SUBJECT: Cummins® and Bosch® Interchangeable Dosers

Cummins gasket 4329681
Note: Sold separately

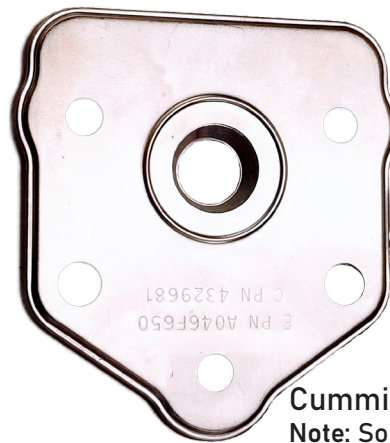
Bosch has four interchangeable dosers which fit various Cummins engines. We have determined the mounting gasket provided from Bosch (F 00B H20 165) may or may not be the correct gasket. Depending on the ESN it may need the Cummins 4329681 mounting gasket and the supplied Bosch mounting gasket must be discarded. The other noticeable difference is the material of the DEF inlet fitting, some may be plastic or a metal fitting. See the table below for the contents of each individual part number.
